Proposal Request

Project:
Intermountain Healthcare Lake Park North Level 1 Remodel
2545 College Drive
Murray, Utah 84123

Date: 07/21/2022
Proposal Request
PR # 01

Purpose for the Proposal Request: These modifications resulted from sewer district review comments, owner requests and contractor questions/ issues discovered during construction.

D2 DEMOLITION FLOOR PLAN - LEVEL 1
AD101 | SCALE: 1/8" = 1'-0"

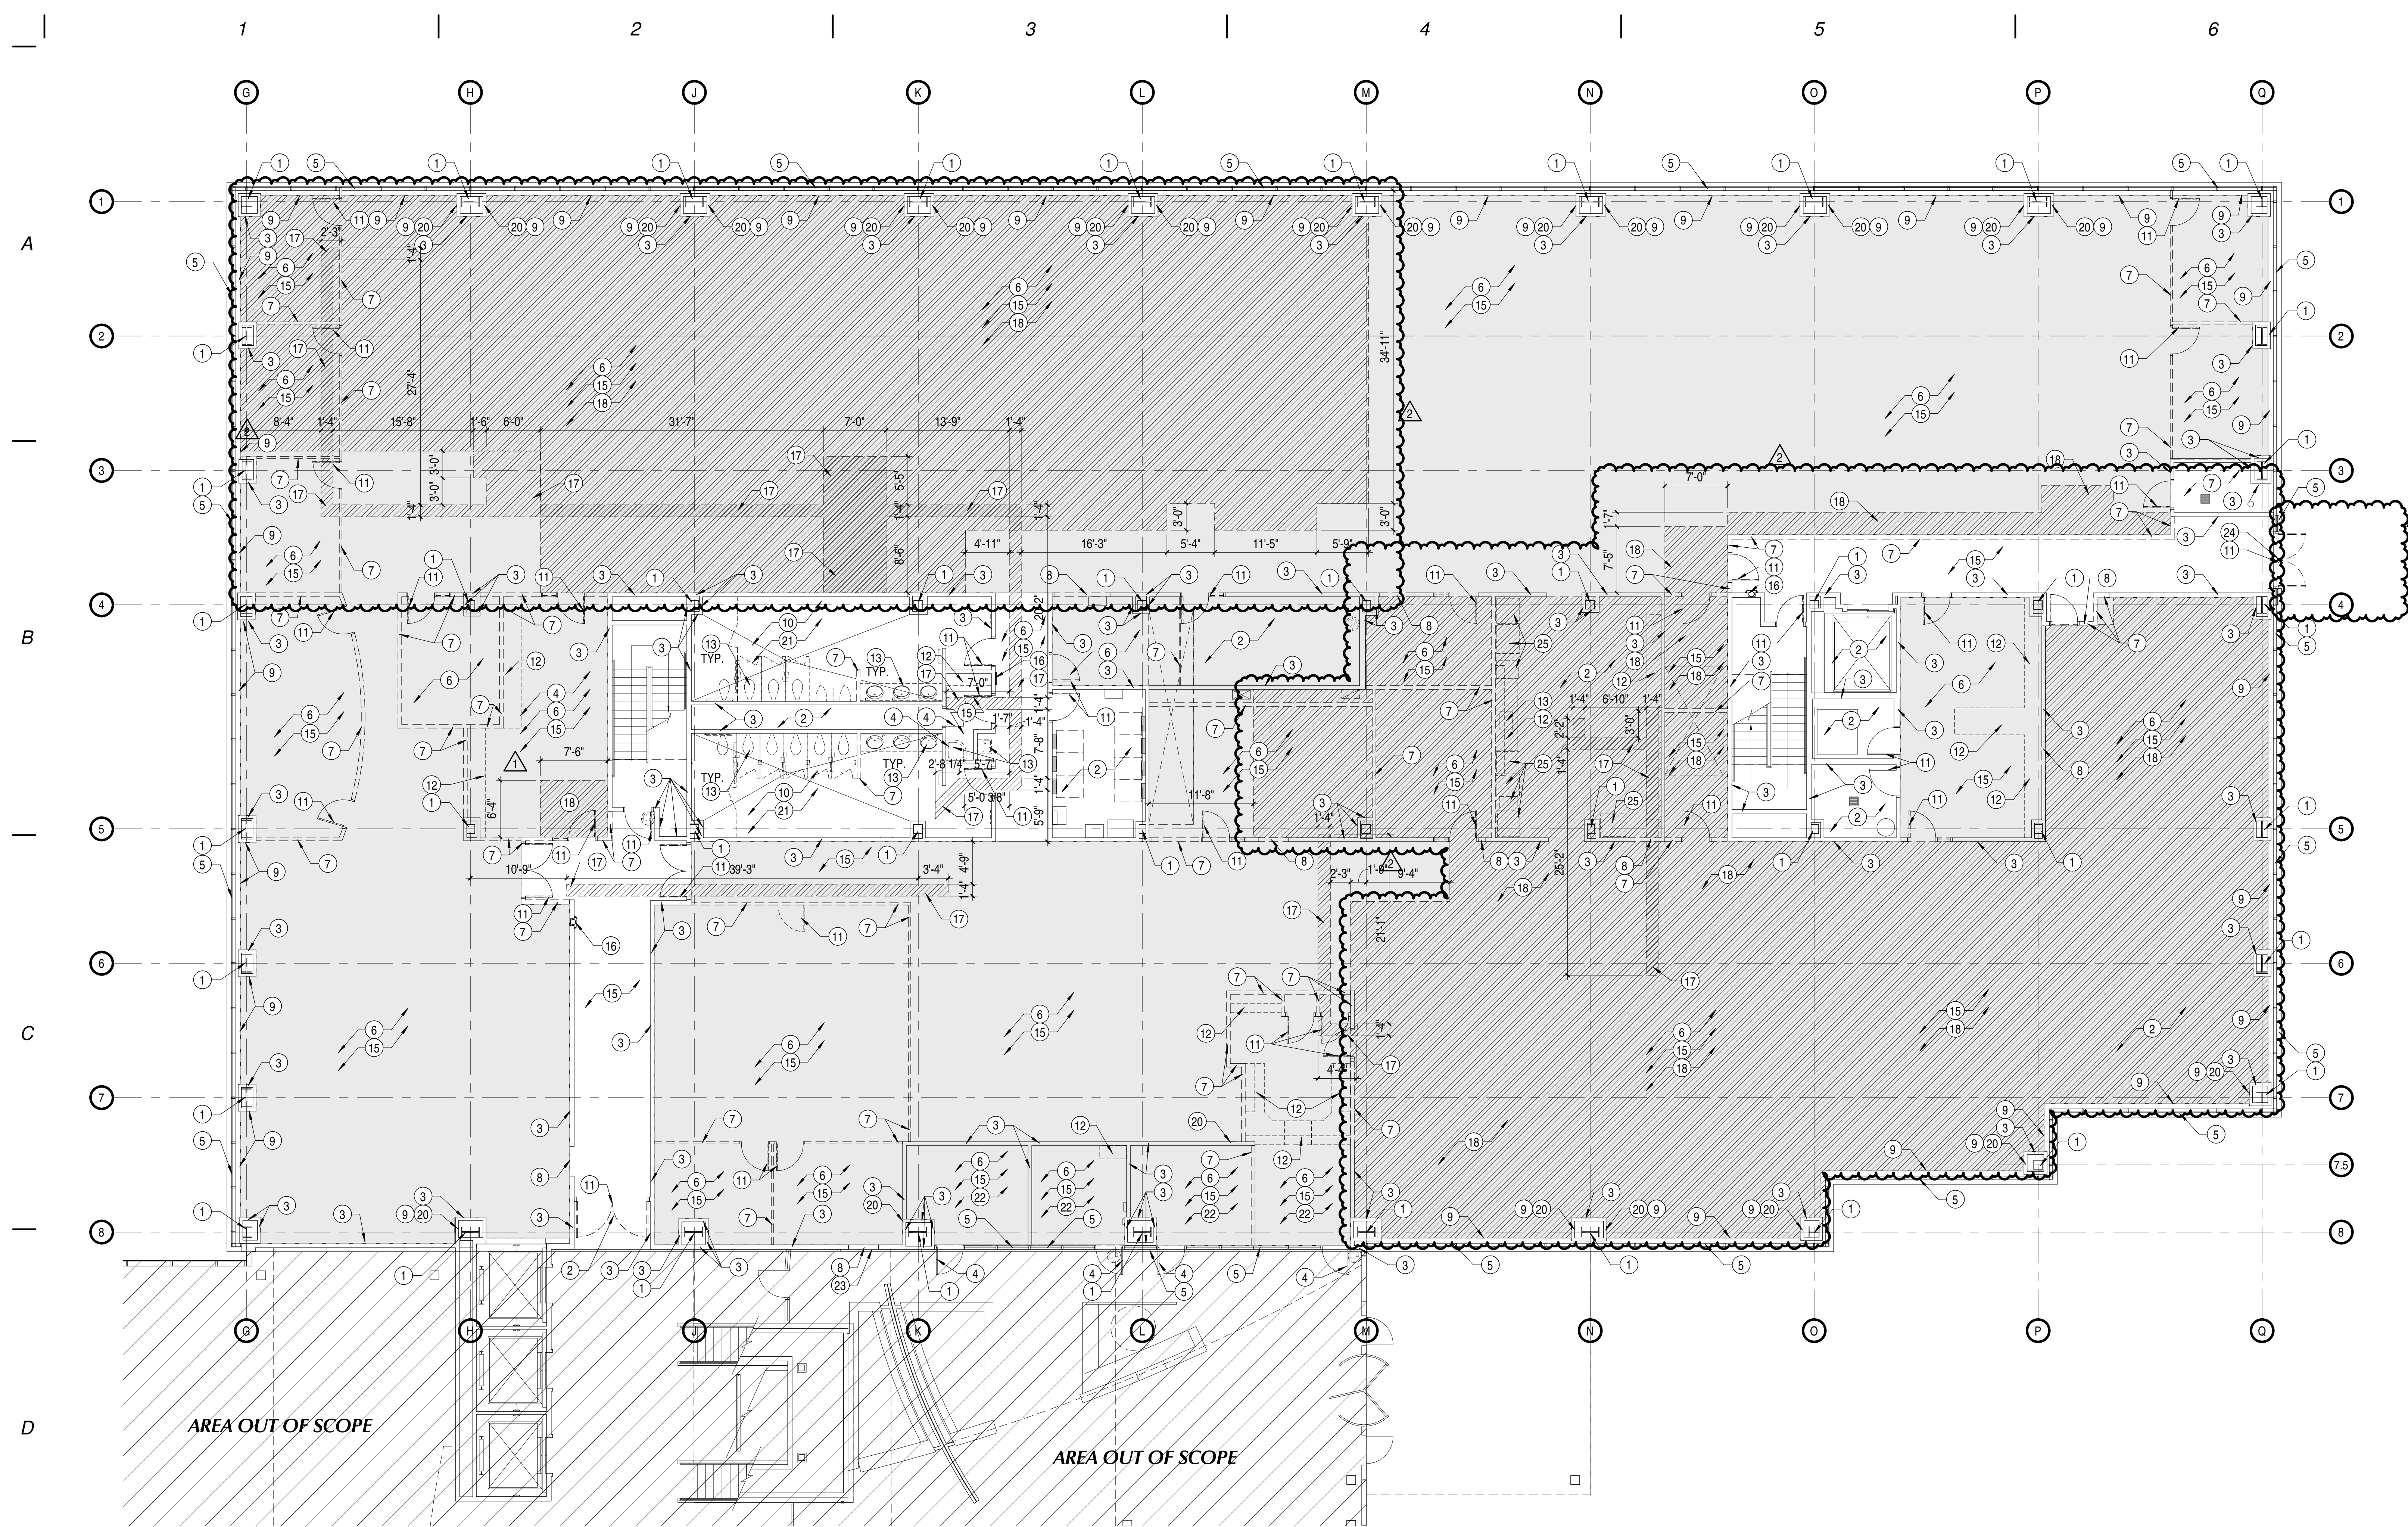
1. **RFI #01:** Per RFI #01, the question was asked whether new walls on raised access flooring had to extend to the lower concrete floor. The response was that new non-rated walls may be constructed on raised access flooring, but that fire rated walls are to sit directly on concrete floor. Due to this, some additional access flooring needs to be demolished and new concrete needs to be poured in its place in Corridor 107. See the original response to RFI #01, and the revised AD101 and A101 (General Note "DD").

tile is to be demolished, the soffit is to be reconstructed, the wall is to be added in Break room #148, the drain line is to be repaired, and the ceiling does not need to be demolished in Security #103. See the original response to RFI #04, the revised AD101 (Sheet Note #10), A101, A151, AI101, AI202, and AP101.

6. **Flooring Changes:** Whereas there were questions on how to maintain warranties on the sheet vinyl system over the raised access floor, various flooring changes have been made. Per Owner direction, some areas of raised access flooring are now being demolished, and some flooring has been changed to a thicker (4mm) version of the originally specified LVT flooring. Storage #139 was changed to LVT, Storage #138, Data Room #143, now won't have any flooring in order to maintain access to the raised access floor, and Utility Room #162 was changed to tile floor and base. Additionally, as part of the flooring submittal review it was determined that the sheet vinyl designations should be Biospec MD rather than FB. See the revised AD101, A101, and AI101.

7. **Exterior Concrete:** It was discovered that the exterior concrete that was noted to be removed and replaced has a snow melt system in it. Per Owner direction, it was decided to leave the existing concrete and to try rework the existing threshold to get as smooth of a transition as possible. See the revised AD101, and A101.

D2 DEMOLITION REFLECTED CEILING PLAN
AD151 | SCALE: 1/8" = 1'-0"

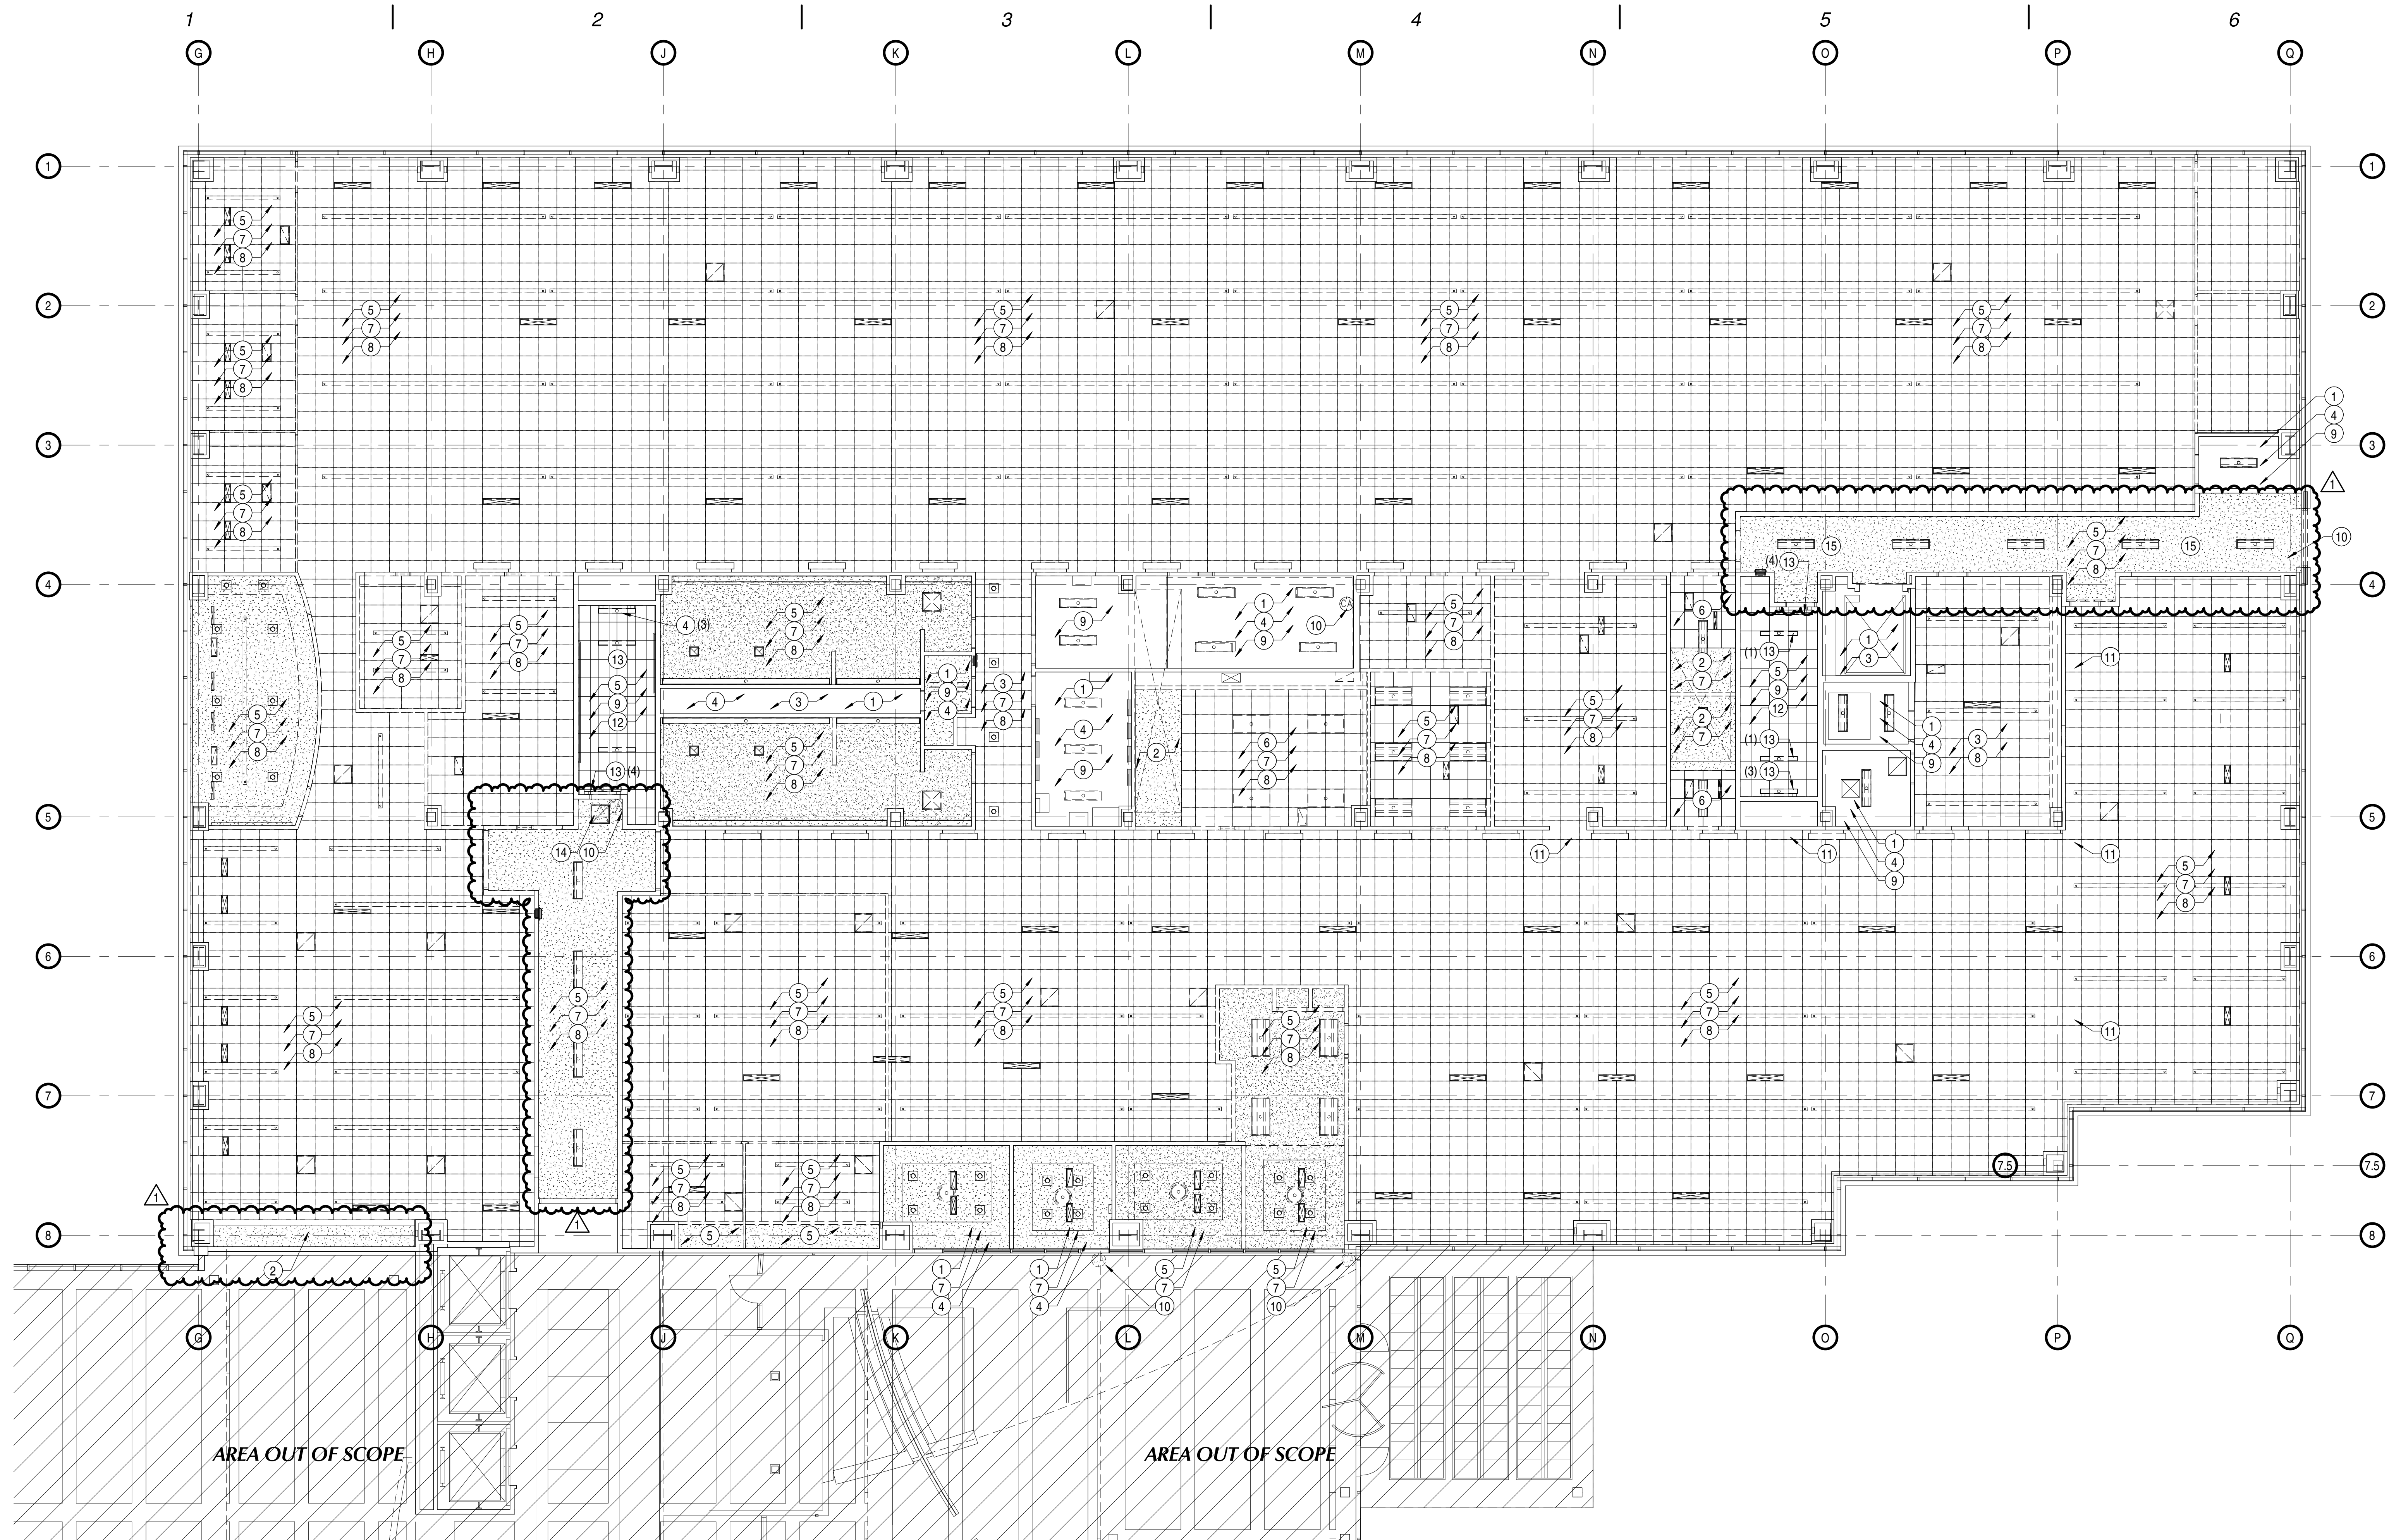
8. **Rated Corridor Ceilings:** It was discovered during construction that the fire rated ceilings that were believed to exist in the Corridor #107 and Corridor #142 are not fire rated. To meet code, it has been determined to demolish the existing ceilings and reconstruct them to maintain a 2 hour fire rating. Wall Type "A" has also been modified to show mineral wool insulation. See the revised AD151, A101, A151, and A501.
